**Medway Planning & Economic Development Board
Meeting**

**Master's Touch Minor Site Plan Public
Briefing – 83 Main Street**

**Re: Master's Touch
Minor Site Plan Review
83 Main Street
Medway, Massachusetts**

INFILTRATION SYSTEM #3

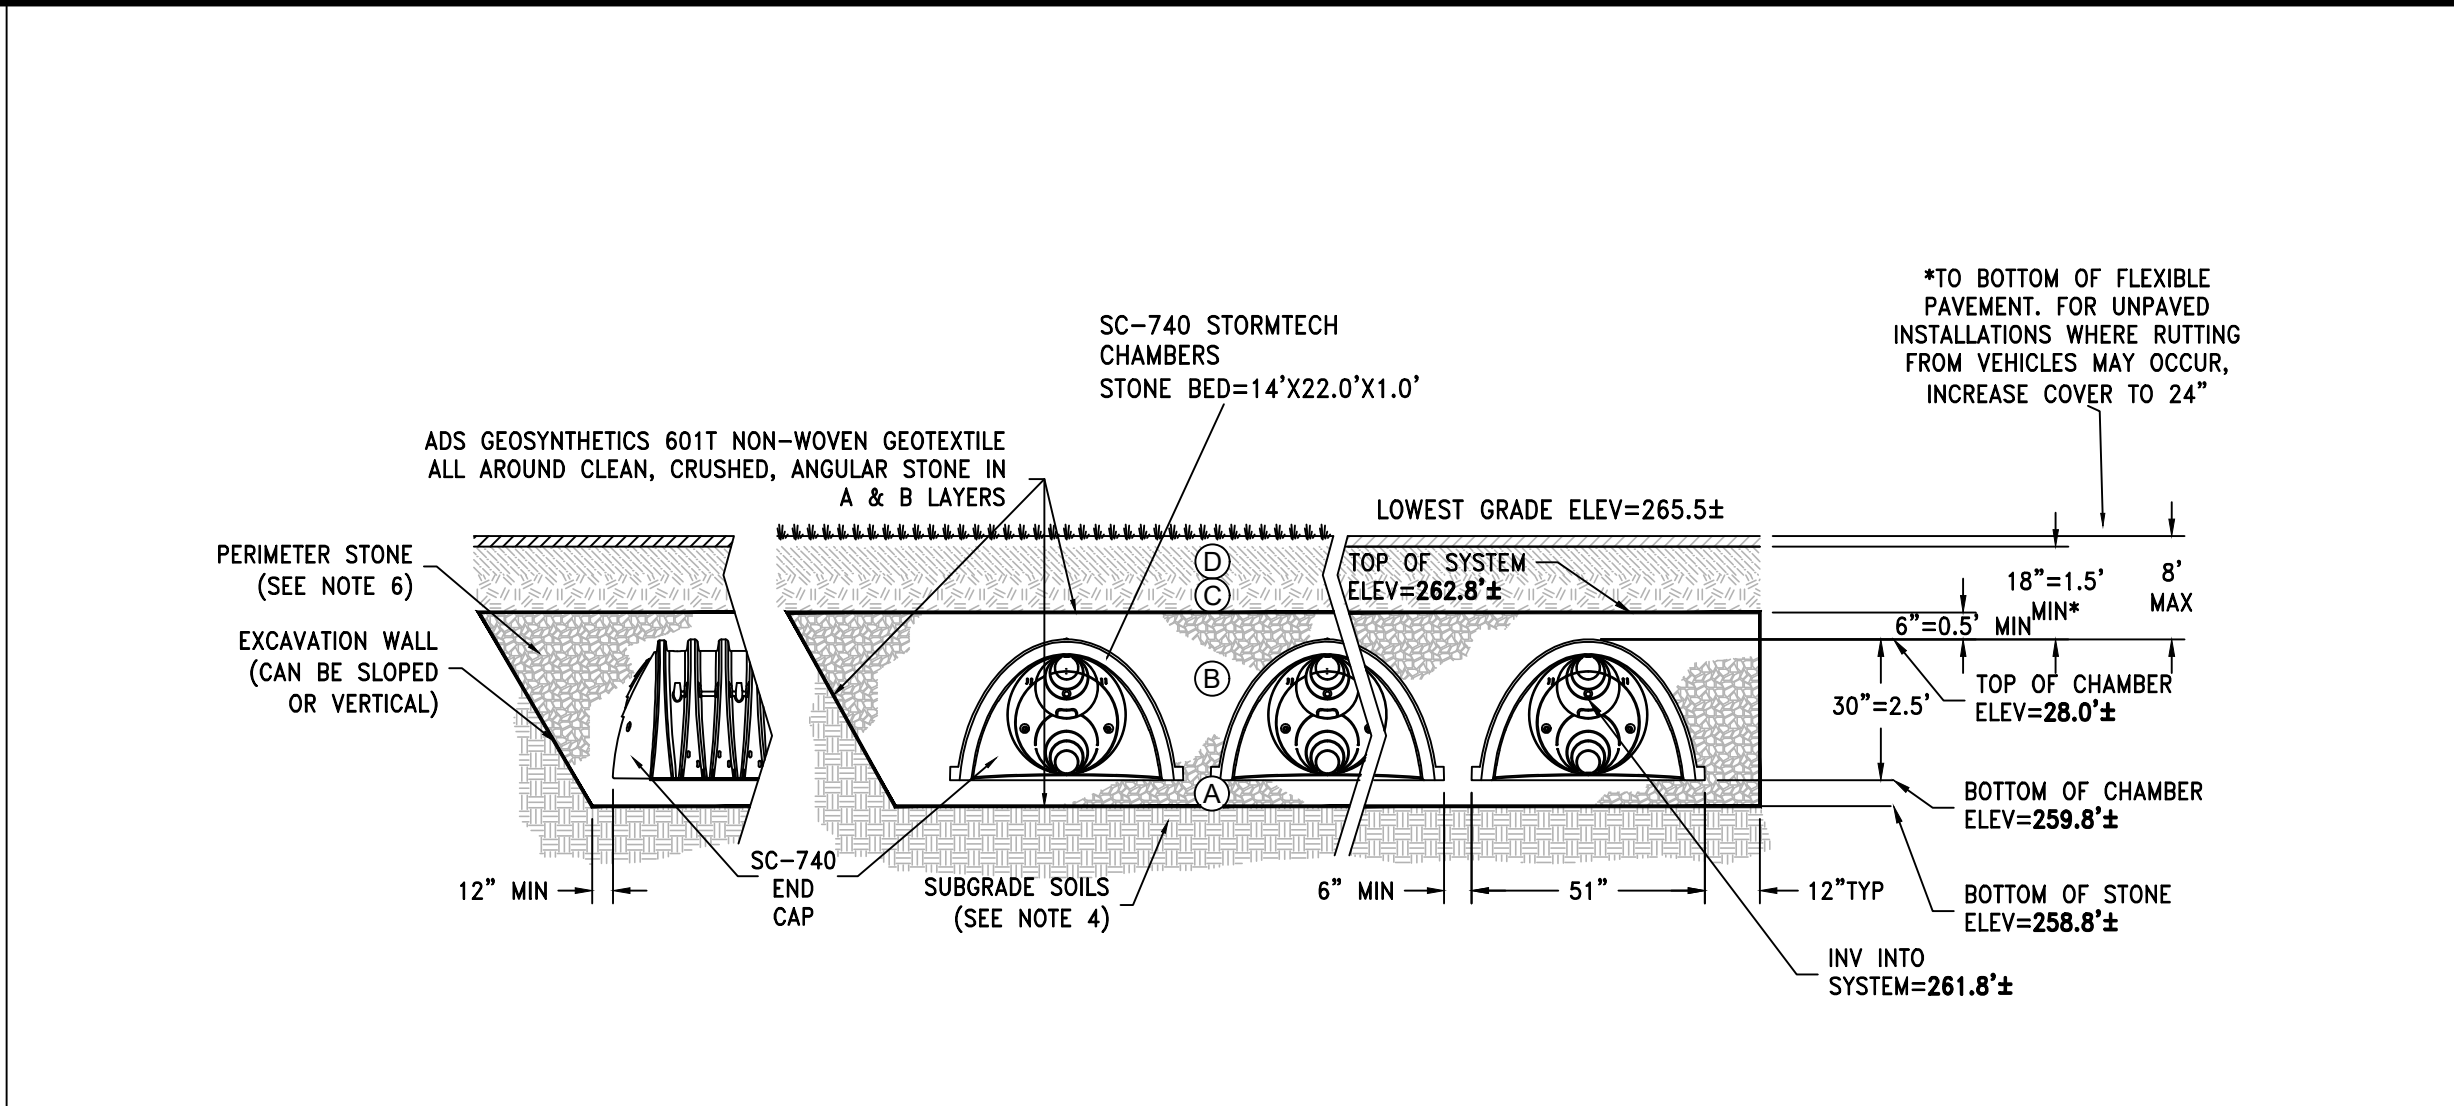
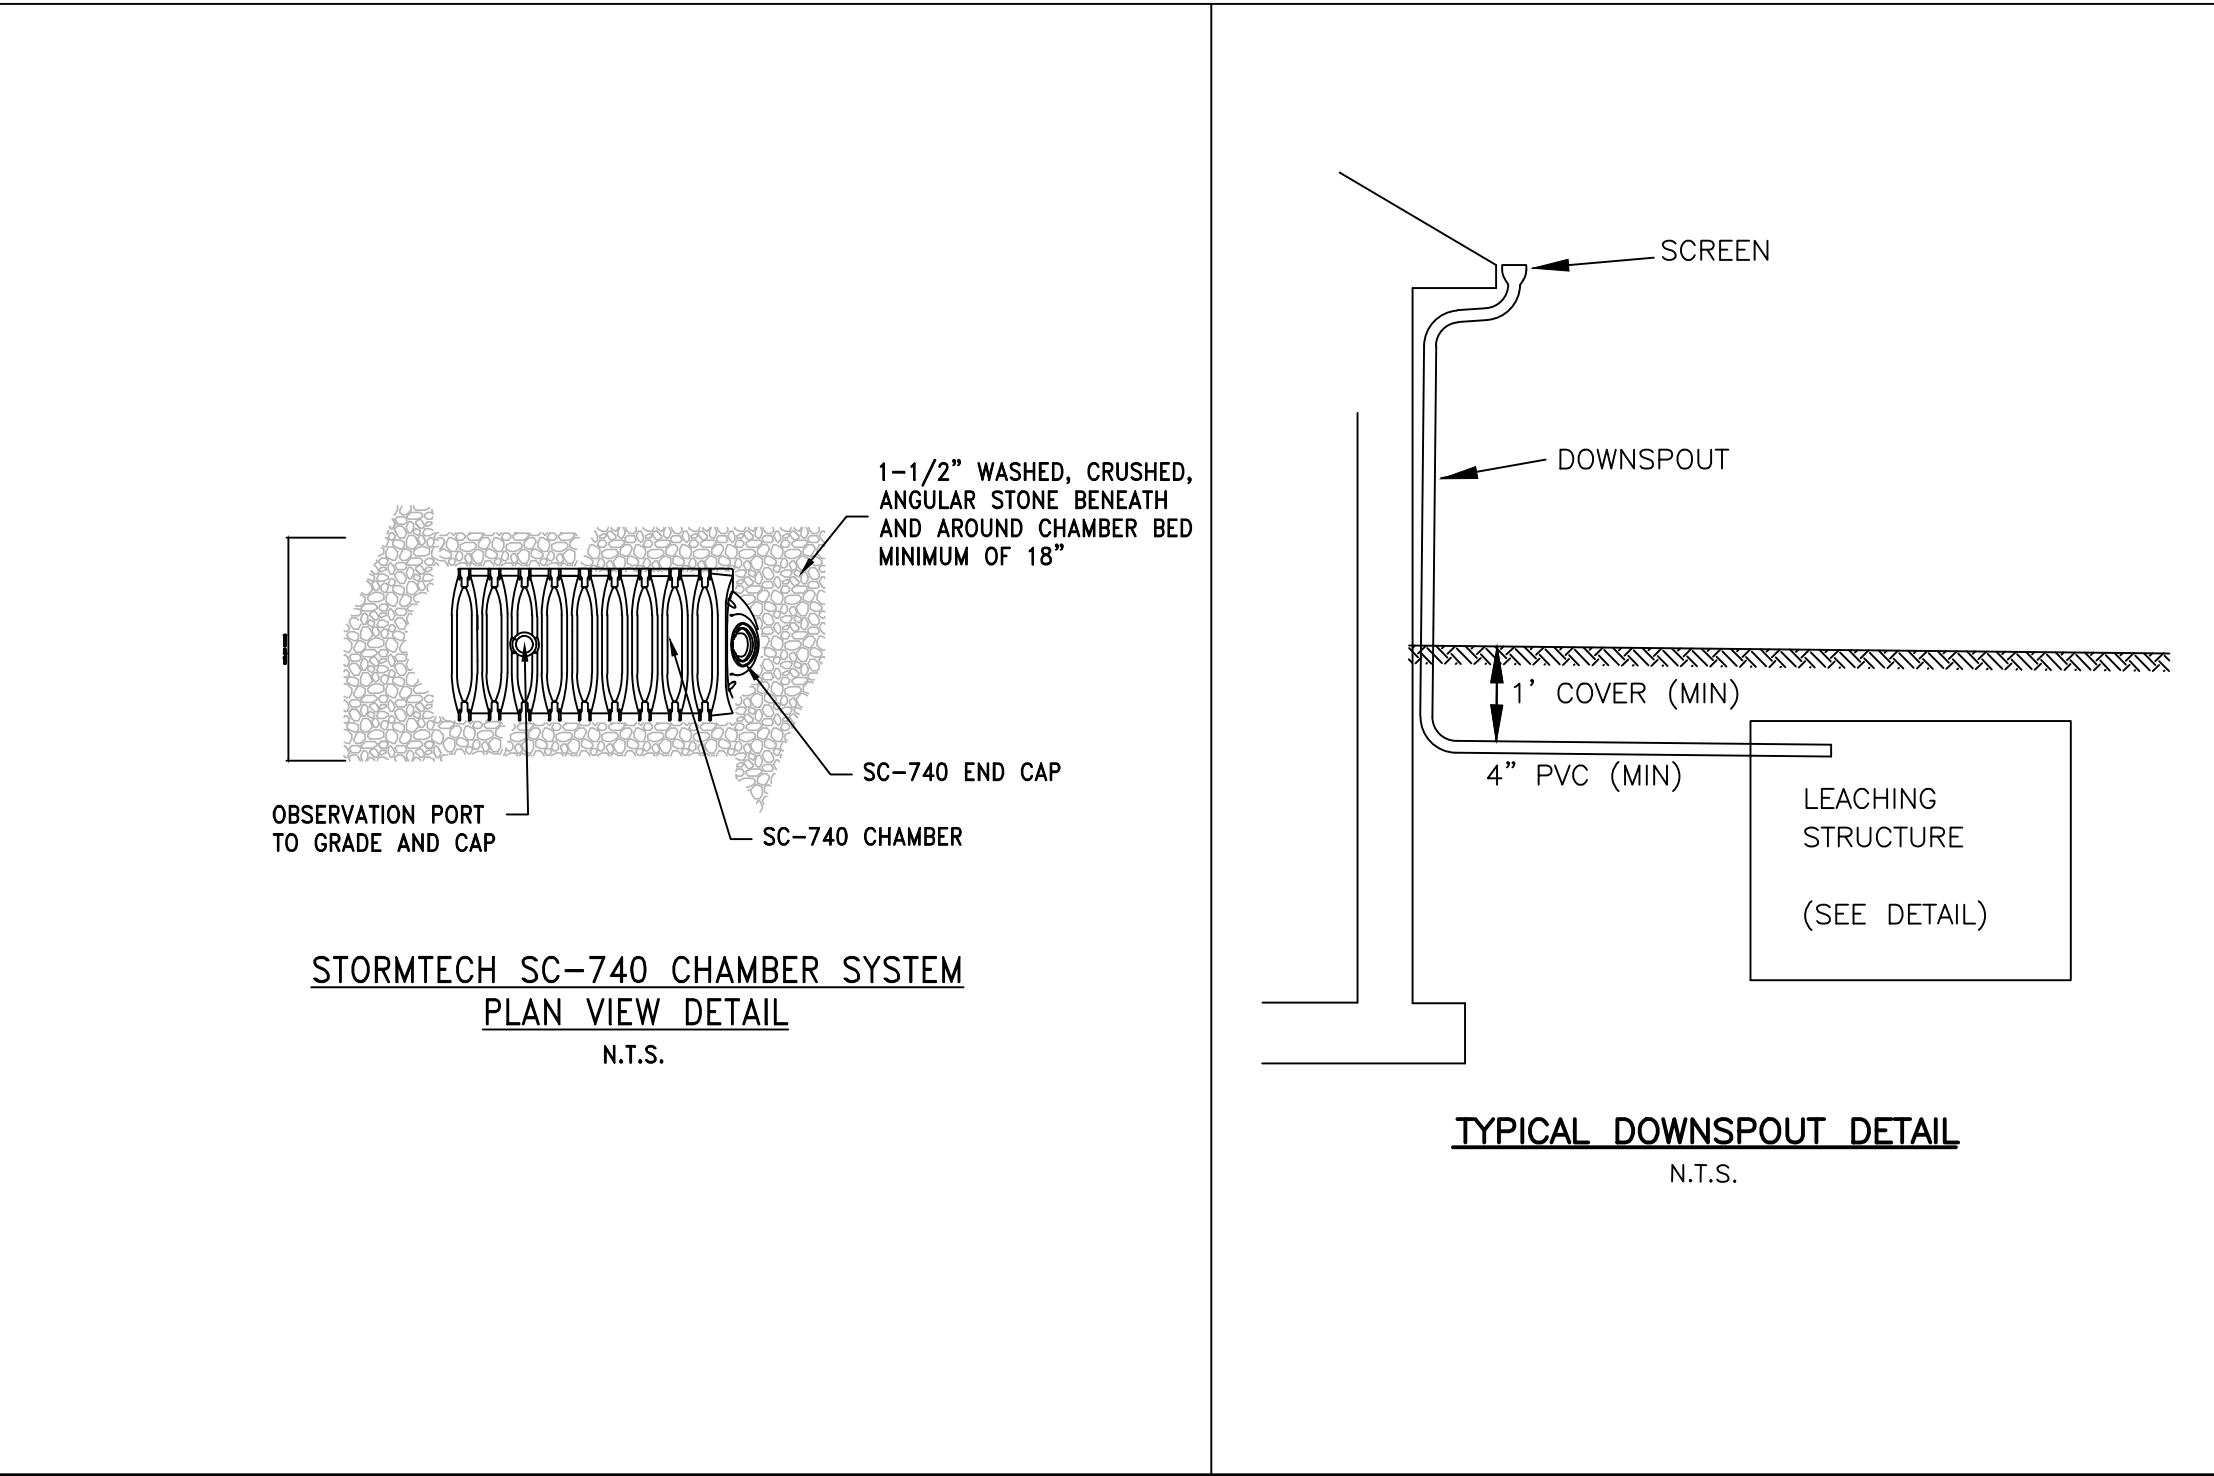
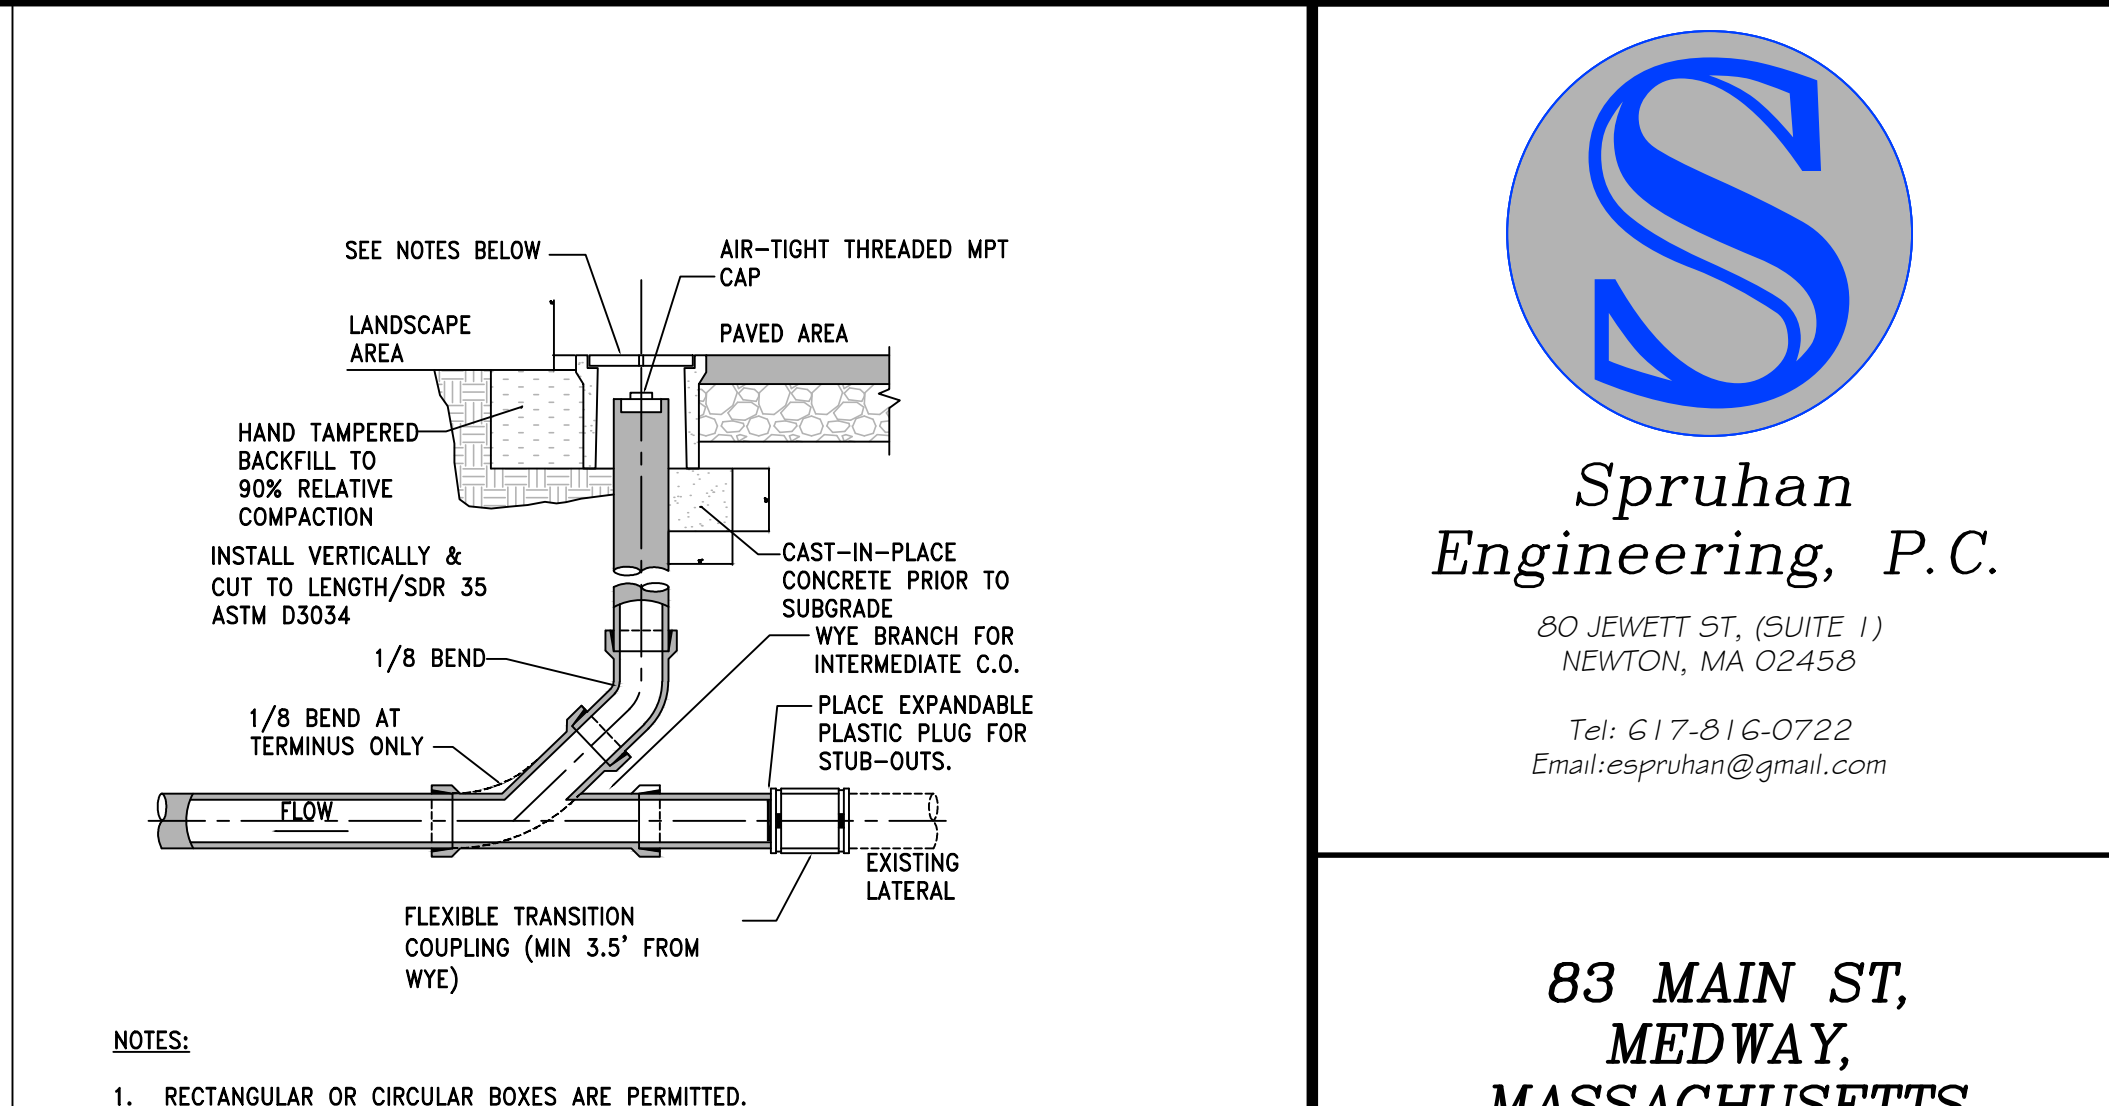
39. Recharge calculations were not provided in the Stormwater Report. (Standard 3)
40. The Applicant is proposing to use infiltration best management practices (BMP's) to mitigate the increase in stormwater runoff as a result of the proposed development of the site. The Applicant has not provided any test pit information to confirm soil texture and estimated seasonal high groundwater (ESHGW) elevation at the location of the proposed infiltration BMP's. (Standard 3)

54. We do not recommend placing fabric under the proposed Stormtech Systems as it may inhibit infiltration as sediment builds in the system.
55. The Applicant used "Wetted Area" to model exfiltration in the HydroCAD model. "Surface Area" shall be used in the model as all infiltration is considered to be vertical in the analysis.
56. The layout of the proposed Stormtech Systems does not appear to show typical installation method. Rows of chambers are typically connected to each other and then stone placed around the entire row(s).
57. Overflow devices should be added to the downspouts to ensure free flow of discharge from the roof drains in the event the SIS becomes over filled.
58. The Applicant proposed a bend in the pipe connection from Catch Basin #3. We recommend a manhole be placed at the proposed bend.
